Subject: Casita Vista Unit II Townhouses

RE: PLAT REVIEW - CASITA VISTA II

SUBJECT: Casita Vista II

DRAINAGE MANAGEMENT  
PLAN

PLATE 2  
OFFSITE DRAINAGE MAP

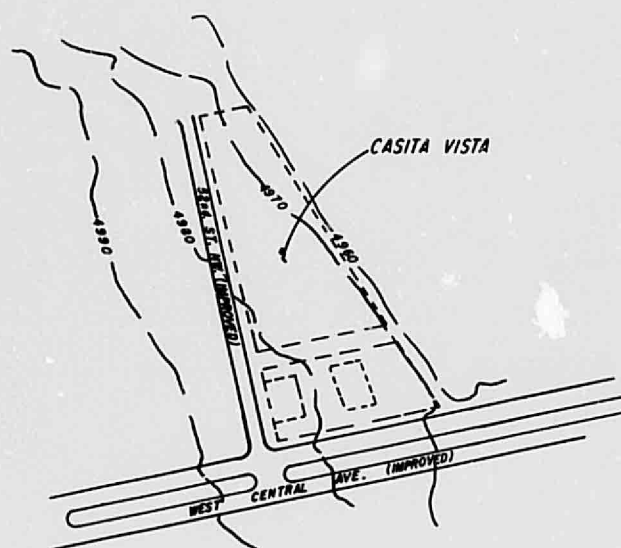
I have reviewed the drainage report for the referenced development, and I cannot concur with the proposal submitted.

A field investigation has revealed that the soil in place is mostly loose alluvial sand with much greater permeability than that exhibited by the soils of the east alluvial fans where a C value of 0.4 is usually adopted. I believe that the existing conditions do not warrant the use of a runoff coefficient C greater than 0.15-0.2.

I also object to the proposal of raising the land by importing fill material and conveying the developed runoff to 52nd Street. The minimal nature of the storm drainage facilities in the valley makes it imperative that no additional discharge be conveyed to already overload facilities, or preempt some of their capacity. My Assistant, Fred Aguirre, has reviewed the computation submitted and found them inadequate (see attachment). I concur with his disagreement, particularly with the use of a runoff coefficient of 0.65 for southwestern landscaping which is normally underlaid by polyethylene film; a value of 0.9 should instead be used.

I further find the drainage report inadequate in terms of the attention paid to the vertical bank, 10 to 15 ft. high, adjacent to the Arenal Canal: Will the ponding areas on top of the slope cause bank failures? A soil engineer report will be required to verify the stability of the slope with the design proposal submitted. Given the circumstances of the site, 100% retention is required. As you may be aware, the development plan shown on the drainage report is at variance with the plan submitted to the Planning Department, and a new action by the E.P.C., will be required. I am forwarding a copy of the plan to Mr. Don Peterson, for his review and follow up.
